The Application for Certification
for the San Joaquin Solar 1 and 2 Hybrid
Power Plant Project

Docket No. 08-AFC-12

CALIFORNIA UNIONS FOR RELIABLE ENERGY
PETITION TO COMPEL PRODUCTION OF INFORMATION
IN RESPONSE TO CURE DATA REQUESTS, SET FIVE

October 26, 2009

DRAWING CONTROL INDEX	PROJECT 1587	CODE 02030	SIZE D	SHEET 1	REV No. 1
SCALE NONE	TOTAL SHEETS 1

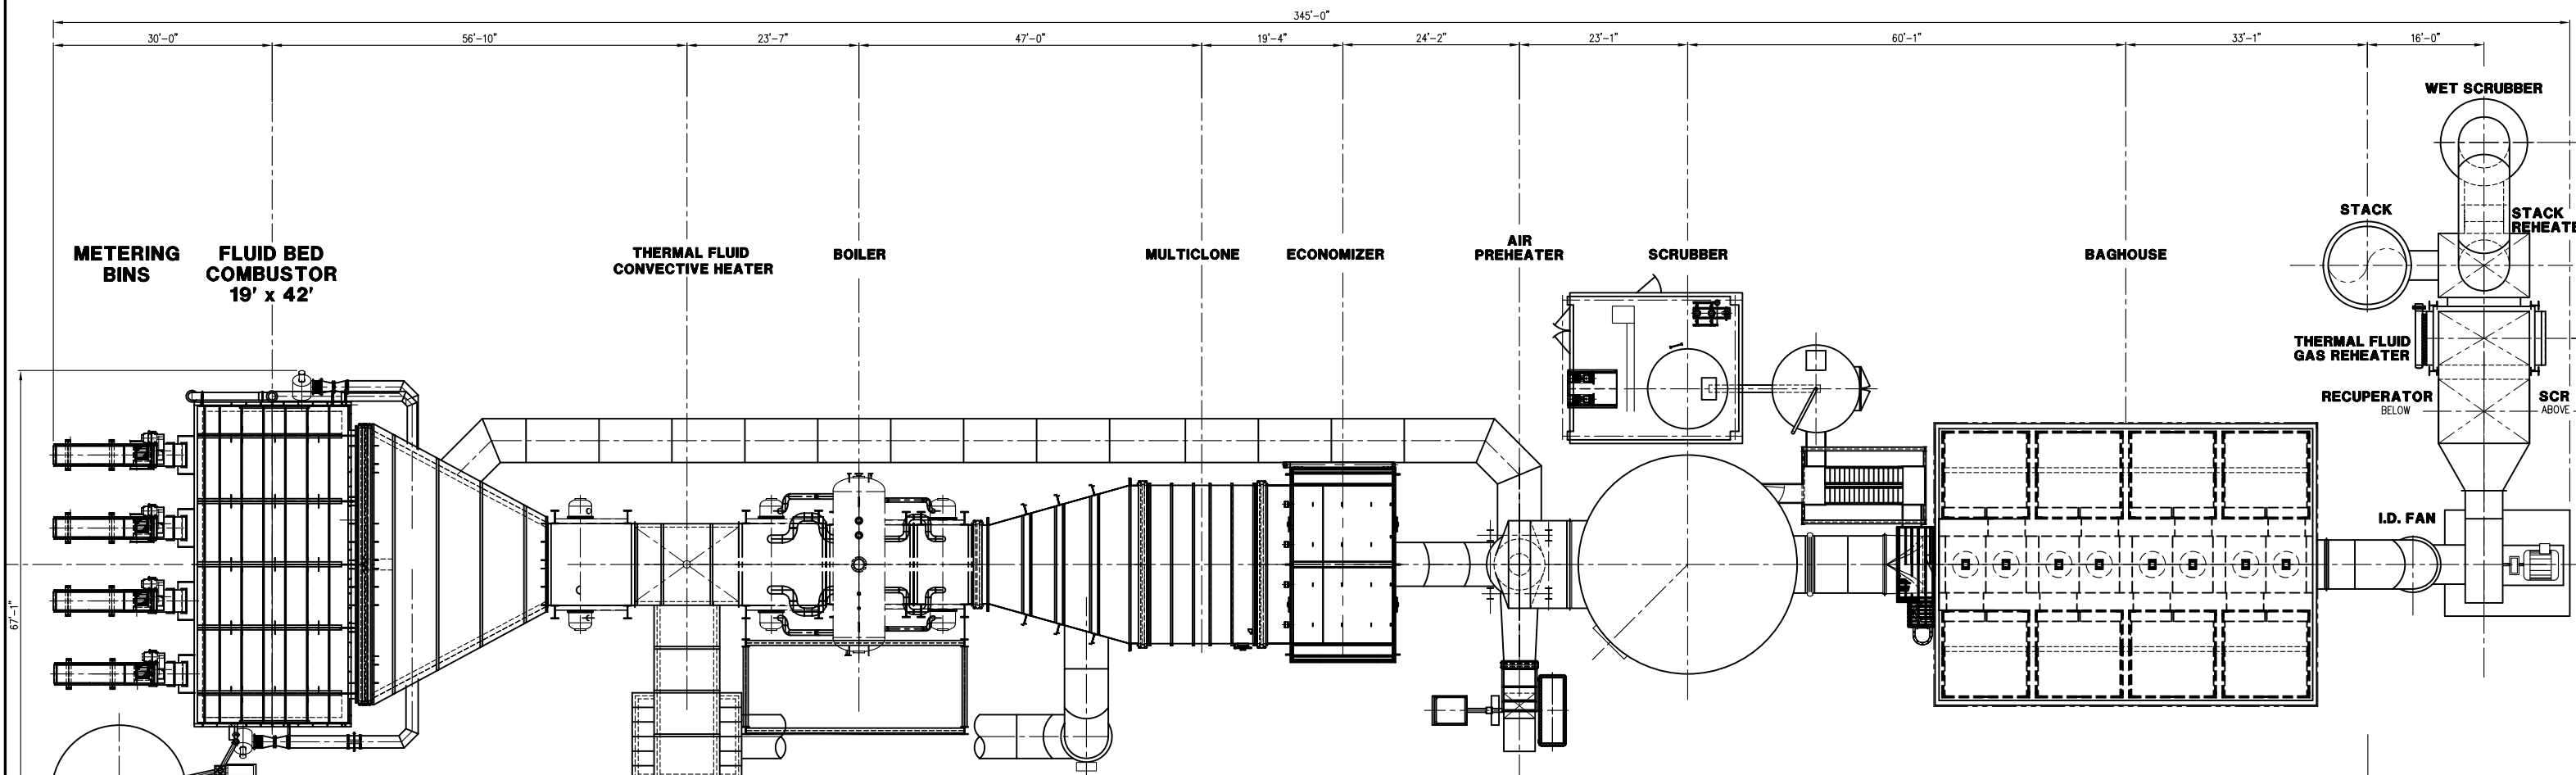
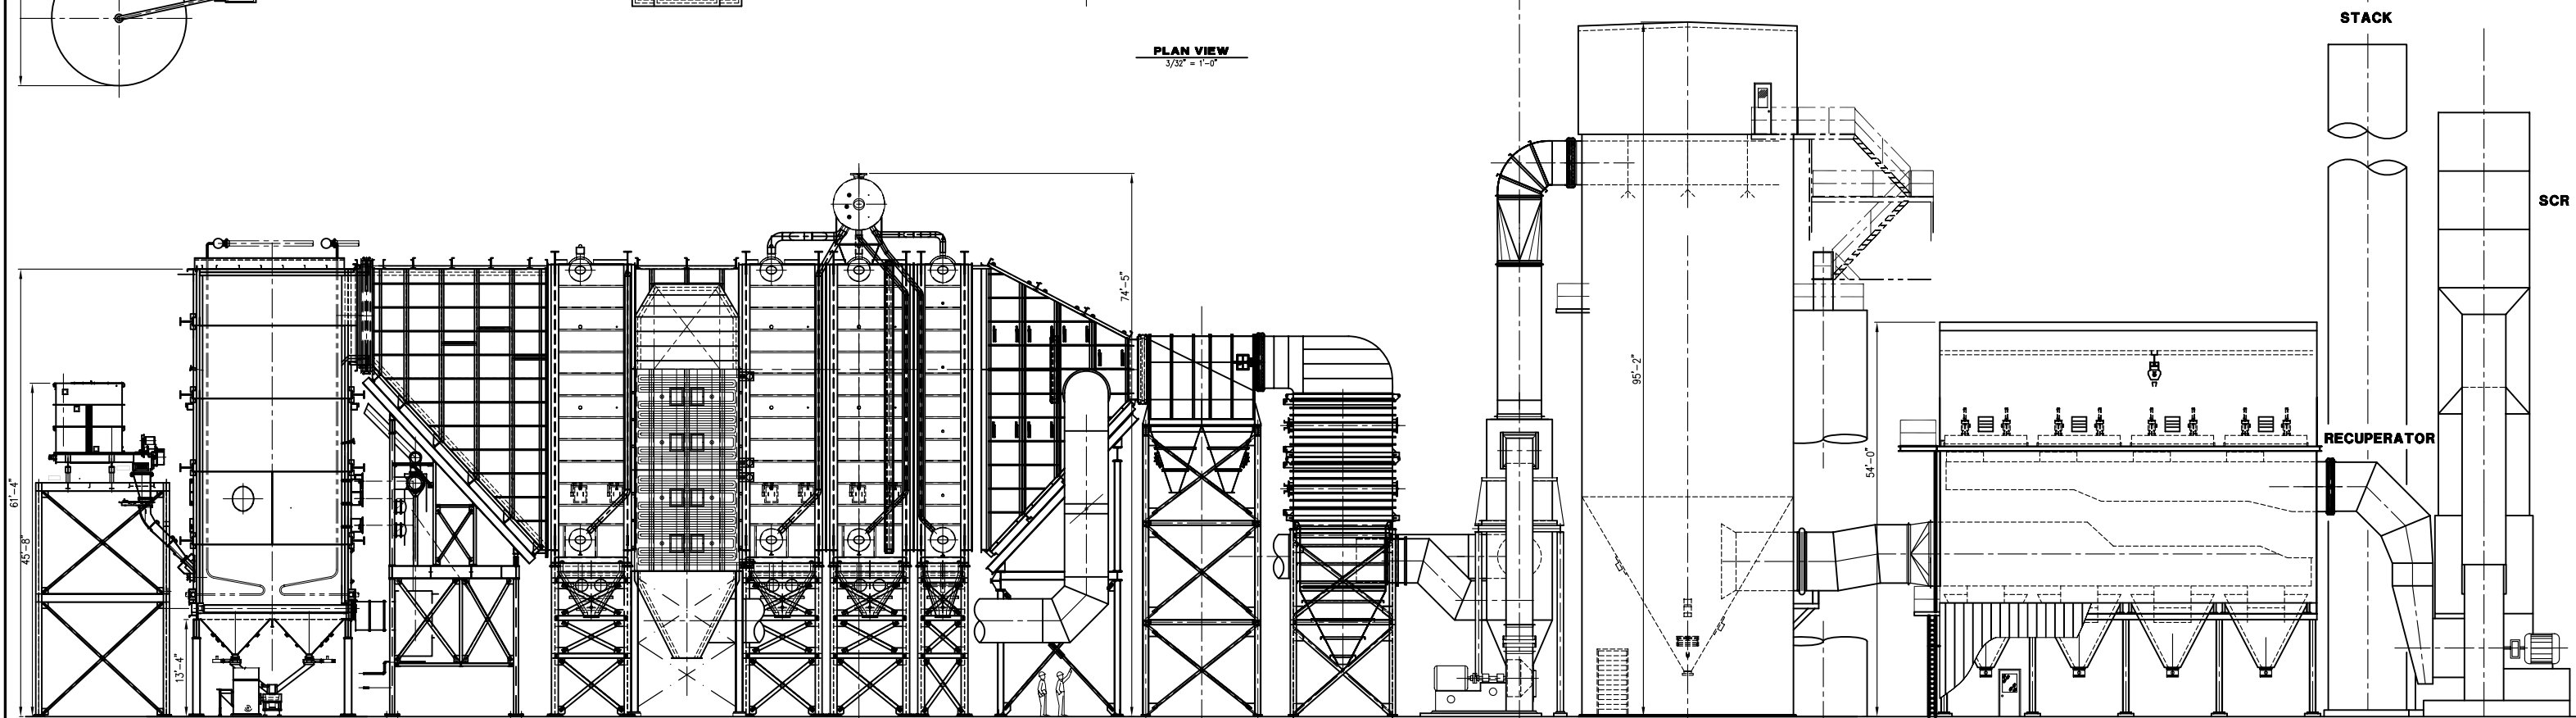
SJS’s response to Data Request 206 is inadequate. While SJS has provided some specifications for the fluidized bed combustors from EPI, it has not provided all of them. For example, SJS has not yet provided the following documents: (1) EPI boiler model data from October 22, 2009 (EPI reference 1587), relied on by SJS for the estimates of “EPI Emission Predictions”;¹² (2) “Data from EPI Emissions Predictions stm 9 26 08.pdf,” relied on by SJS for the estimates of the Project’s CO₂

The applicant has provided many specifications for the fluidized bed combustors from EPI. The vendor specifications for the fluidized bed combustors such as equipment dimensions or materials of construction are not finalized, but a preliminary general arrangement is shown in the attached figure.¹¹

Figure 3. Anderson Pumping Well (Drawdown)

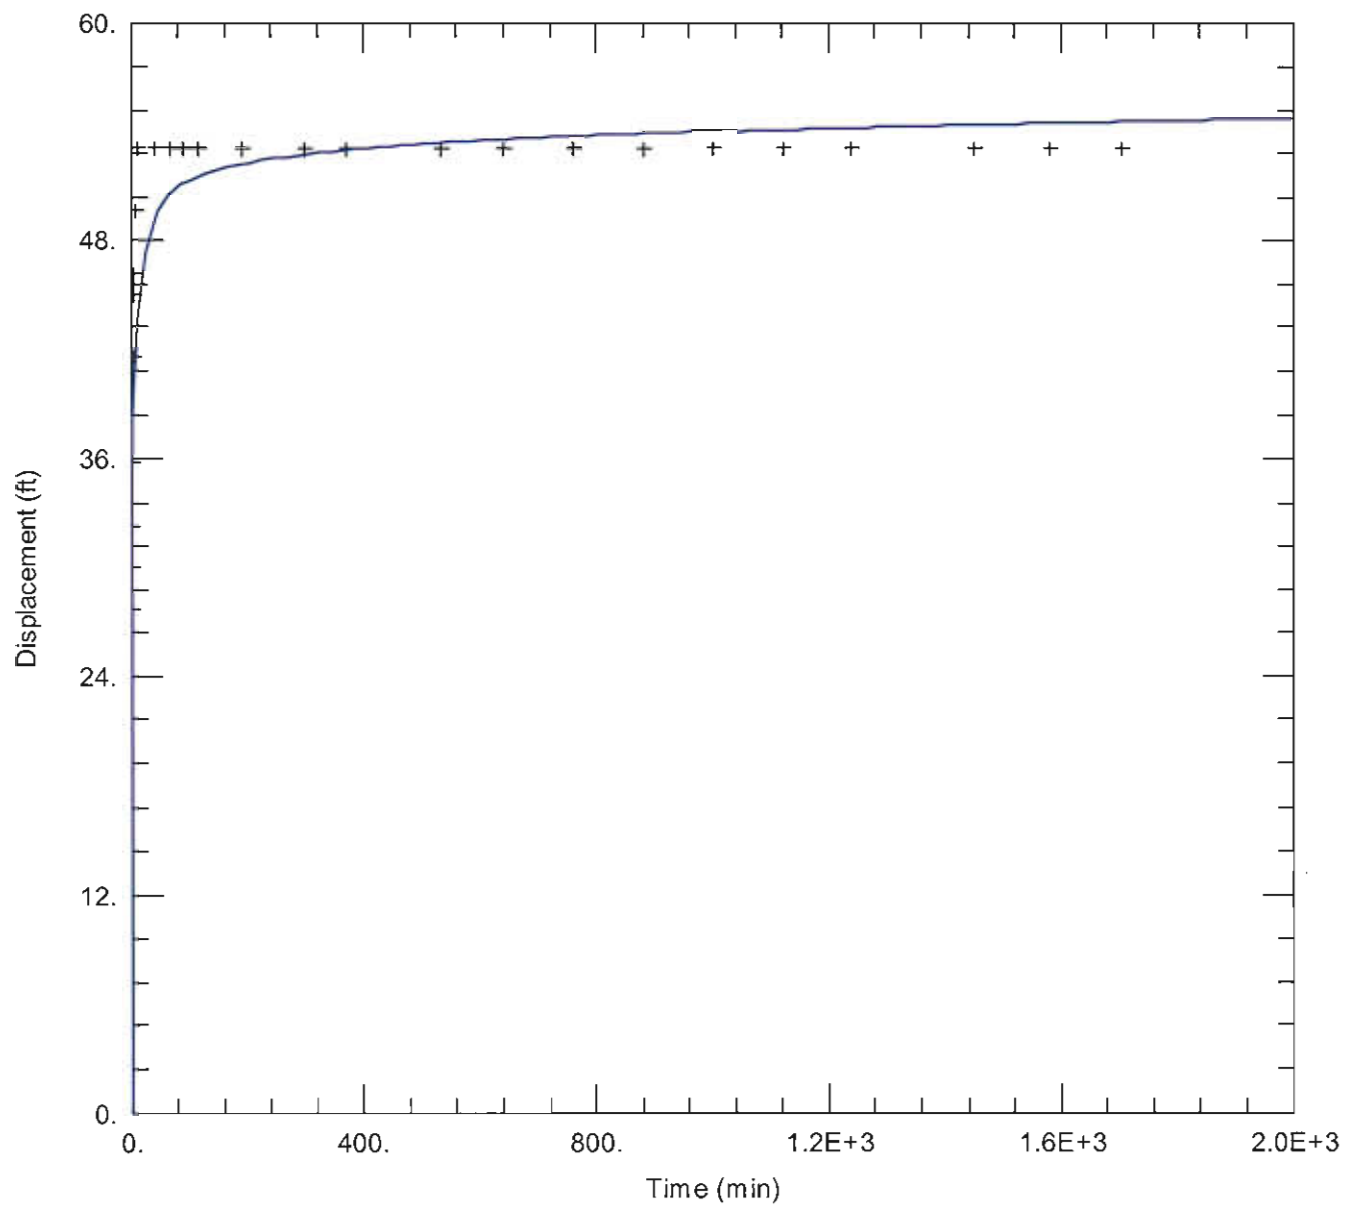
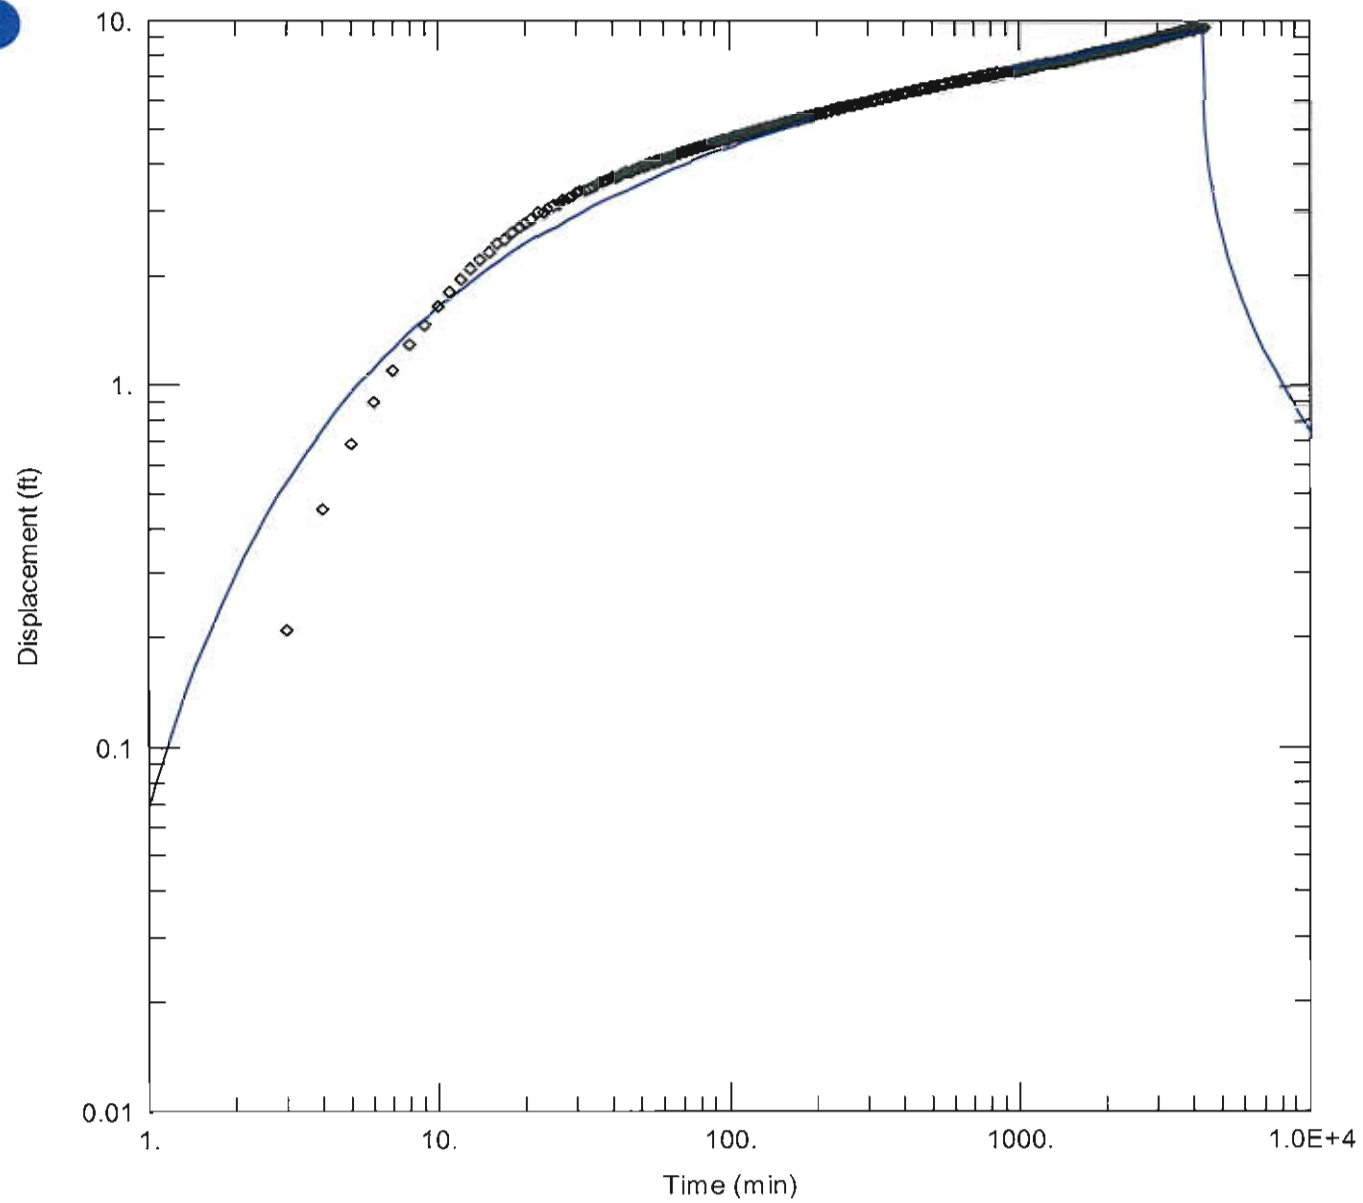
- 1) The Theis (1935) analytical method was developed for use in confined aquifers using pumping and observation wells which fully penetrate the aquifer being tested. There is no data presented by the Applicant to support classification of the tested aquifer as being confined; in fact, the reported screen interval for the test well is as shallow as 370 feet bgs, within a zone identified as an unconfined aquifer by the State Department of Water Resources in the Pleasant Valley groundwater basin (DWR web site, www.sjd.water.ca.gov/groundwater/basin_maps). Figure 5 within the Applicant's report suggests some evidence of delayed yield (gravity drainage), a characteristic of unconfined aquifers. Such patterns are often muted on standard Theis log-log data plots. Alternatively plotting the time-drawdown data on semi-log format would better elucidate this aquifer response. Alternative conventional analytical solutions other than the Theis method exist which are known to produce more reasonable estimates of unconfined aquifer yield and behavior (i.e., Neuman; Moench; others).

the “average behavior” of multiple saturated zones of different character (Bennett and Patten, 1962). The reported storativity value reported by the Applicant from the aquifer test (0.001) is actually greater than the range typically observed in confined aquifers (Domenico, 1972; Freeze and Cherry, 1979). Finally, within the *Response To CEC Data Adequacy Requests 08-AFC-12* (Water Resources: Data Adequacy Request #2), the Applicant responds that “the existing on-site <test> well (as currently screened) likely draws water from both the upper and lower water-bearing zones”;

- 2) The Theis (1935) analytical method is recognized as providing best estimates of aquifer response nearer to the pumping well, since it was developed to analyze removal of water from storage and assumes non-steady-state aquifer response (e.g., the well capture zone continuously expands with continued pumping over time) (Domenico, 1972; Butler, 1990; Kruseman and deRidder, 1990); it is less meaningful in estimating aquifer response near the outer fringe of the capture zone, and thus the impact upon neighboring wells located at distance from the test well. The assumption of non-equilibrium behavior also tends to lead to overestimates of long-term aquifer yield, since a given applied pumping stress will yield water from an infinitely-expanding capture zone. Alternative methods, such as Cooper-Jacob, should provide more
